ADDENDUM NUMBER TWO

PROJECT NUMBER 1110393

VISITOR CENTER ROOF REPAIRS AND REPLACEMENT

LONGHORN CAVERN STATE PARK

SCALE: N.T.S. **ANTENNA ANCHOR DETAIL** 10

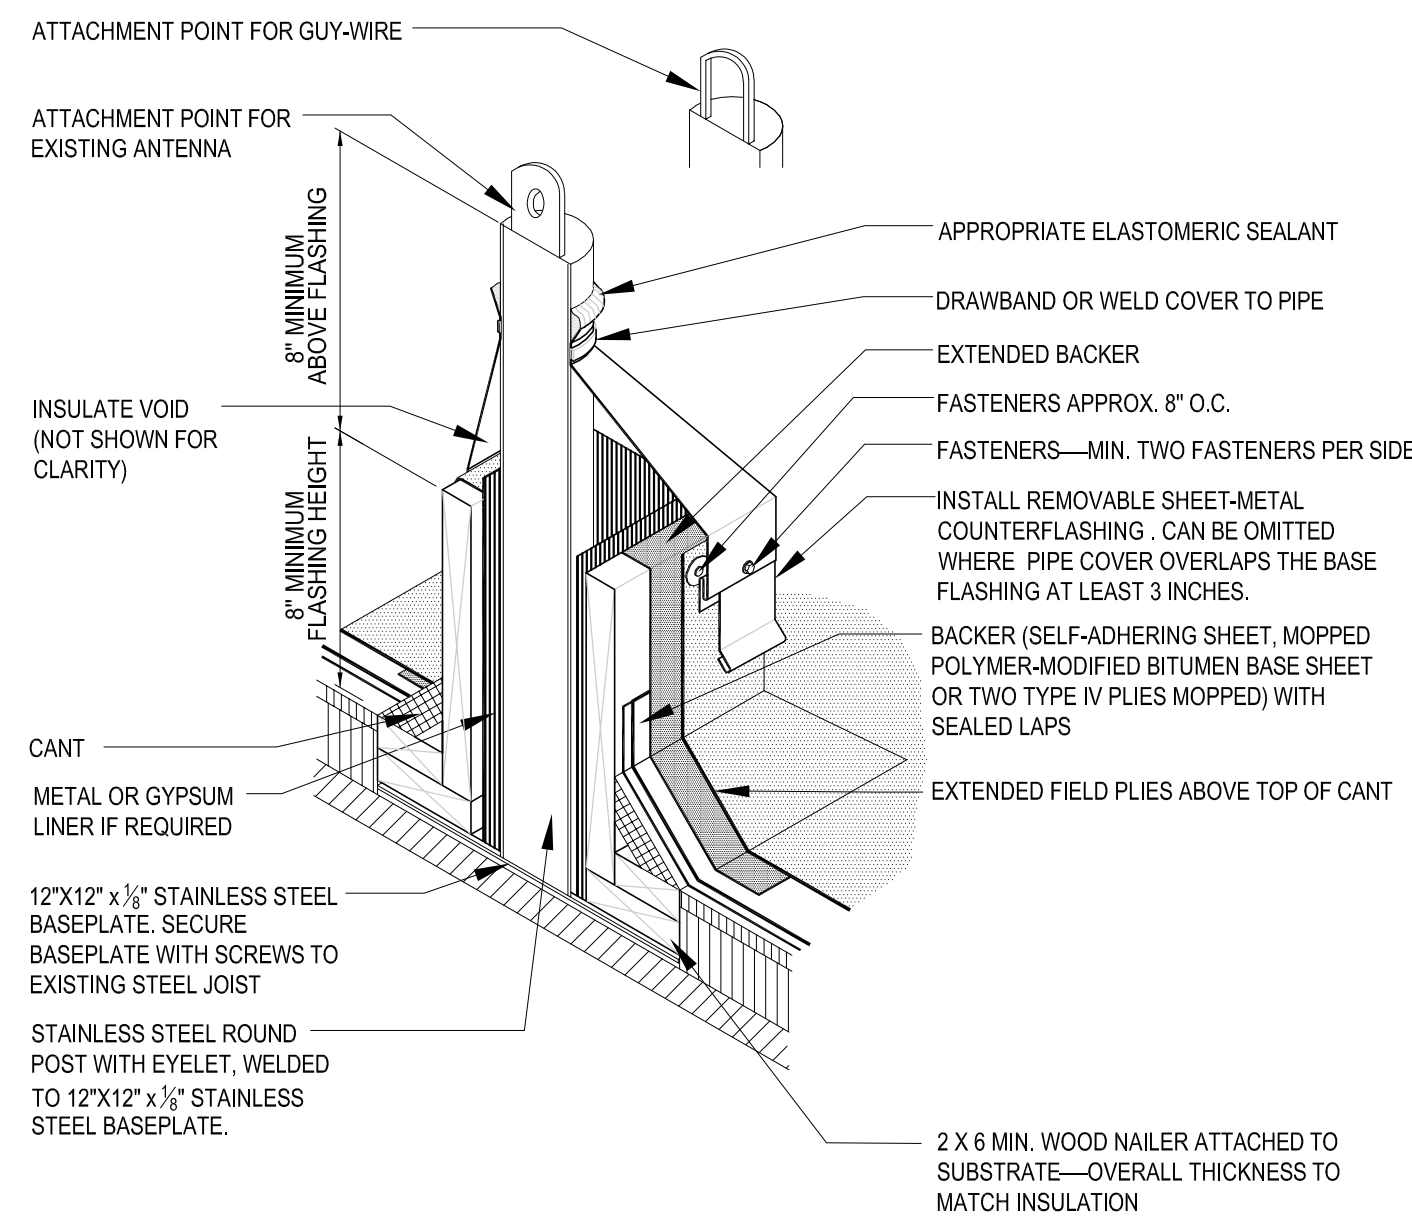
16. Per Detailed Note indicating Antenna on Sheet A2, how long and how many guy wires are required to be install on the antenna?

Three guy wires are required, attached at mid-point with guy ring and clamp. Length of guy wires can be adjusted depending on anchorage points.
